May 20, 2010

**ADDENDUM NO. 1
FOR THE
SJEIC-NEW ELECTRICAL TRANSFORMER PROJECT**

CITY OF SAN JOSE
TRANSFORMER RELOCATION
1608 LAS PLUMAS, SAN JOSE, CA.

CONSTRUCTION SKETCH

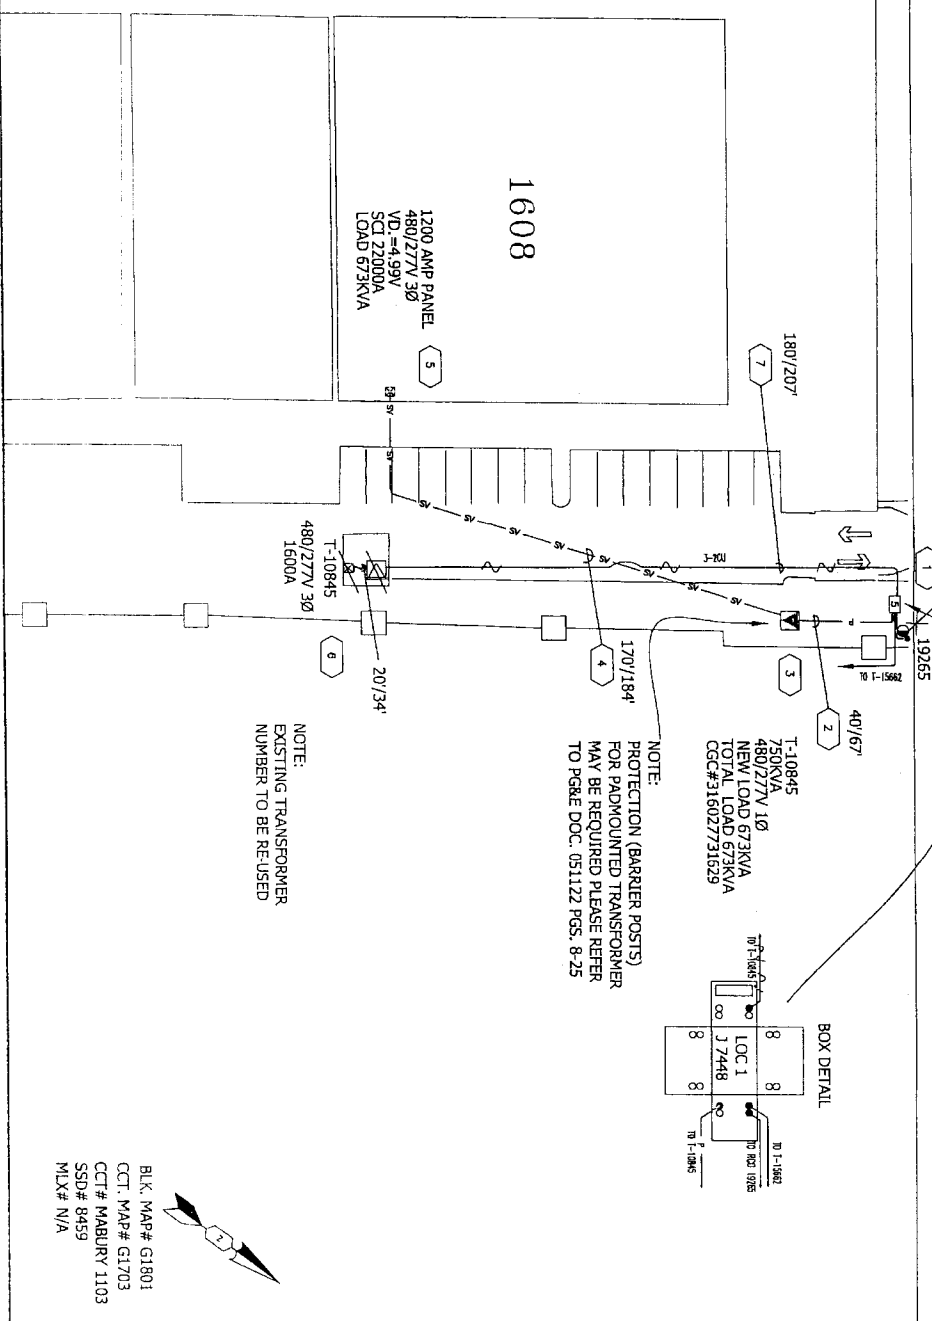
PG&E TO INSTALL 3-1/0AL 25KV ENCAP IN 1-4" APPLICANT INSTALLED CONDUIT

PG&E TO INSTALL CABLE, SVC, XLPE, 3-1/C 600V 1000A & 1/C 350A IN 2 OF 4-5" APPLICANT INSTALLED CONDUITS

PG&E TO INSTALL 750KVA 12/21-480 IIE PM ON APPLICANT INSTALLED 90X106 PRECAST TX PAD 3PH IIE (04-0292)

PG&E TO REMOVE 3-2CU 15KV IN 1-4" EXISTING CONDUIT

PG&E TO REMOVE 750KVA 12/21-480 PM TRANSFORMER

NOTE:
PROTECTION (BARRIER POSTS)
FOR PADMOUNTED TRANSFORMER
MAY BE REQUIRED PLEASE REFER
TO PG&E DOC. 051122 PGS. 8-25

NOTE:
EXISTING TRANSFORMER
NUMBER TO BE RE-USED
